1965 - 1978 Corvette: Service Bulletin: Servicing Disc Brake Calipers

Subject: Servicing Disc Brake Calipers

Model and Year: 1965 - 1978 Corvette

Bulletin No: 74-T-41

FIGURE 1

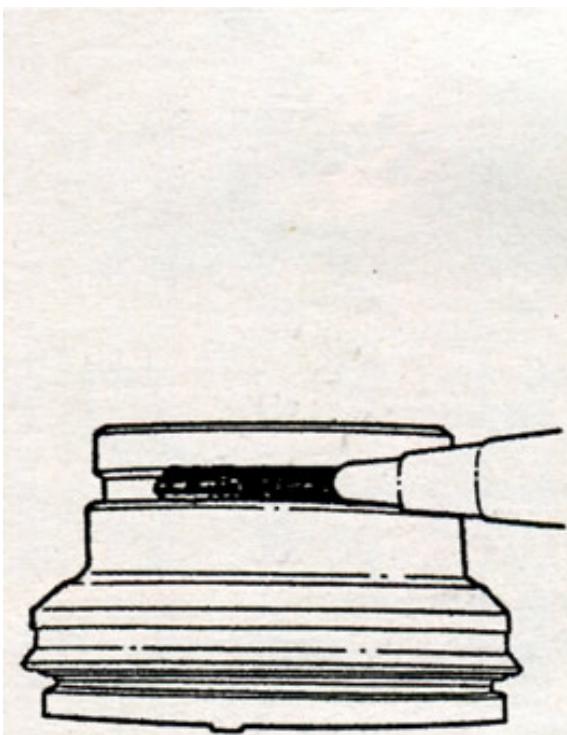
1. Assemble the seal in piston groove. The lip of the seal must face large end of piston. Be sure lips are in piston groove, and do not extend over the step in end of groove.
2. Place the spring in the bottom of piston bore.
3. Lubricate the seal with clean brake fluid.
4. Place a bead of silastic sealant (P/N 1052366) or equivalent into boot groove on piston (see Figure 1).
5. Install the piston assembly in bore using an appropriate piston ring compressor tool. Use care not to damage seal lip, as piston is pressed past edge of bore.
6. Assemble the boot in piston groove. The fold in boot must face toward the end of piston with seal on it.
7. Depress the pistons and check that they slide smoothly into the bore until the end of piston is flush with end of bore. If not, recheck the piston assembly and location of spring and seal.

FIGURE 2

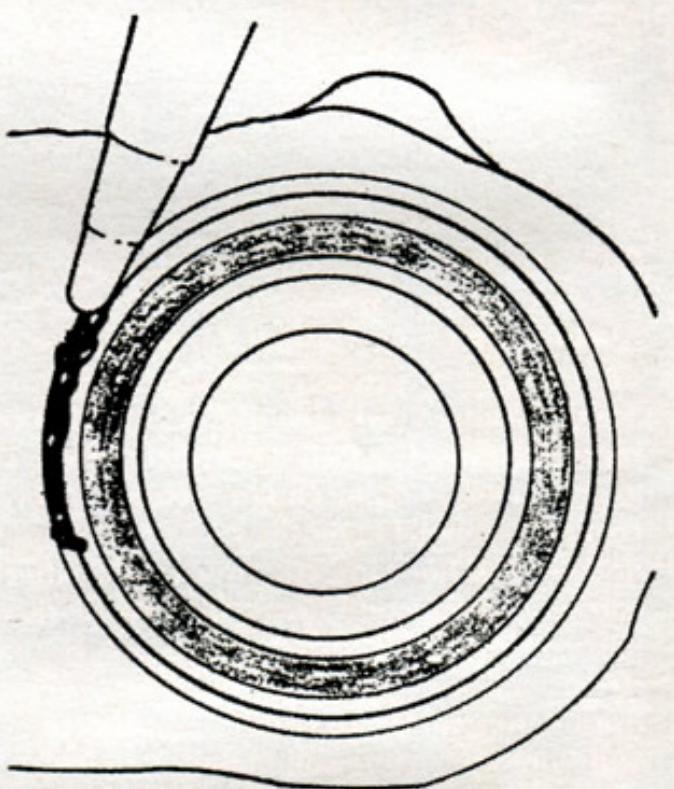
8. Position the boot seal installer tool over the piston, and seat the steel boot retaining ring evenly in the counterbore. The retaining ring must be flush or below the machined face of the caliper.
9. Depress pistons and, while holding in a depressed position, place a bead of silastic sealant (P/N 1052366) or equivalent on the outer diameter of boot retaining ring (see Figure 2) forming a seal between ring and housing.
10. Position the "O" rings in small cavities around brake fluid transfer holes in both ends of outboard caliper halves. Lubricate the hex head bolts with Delco brake lube or dip in clean brake fluid. Fit caliper halves together and secure with bolts. Torque bolts to specifications as follows:
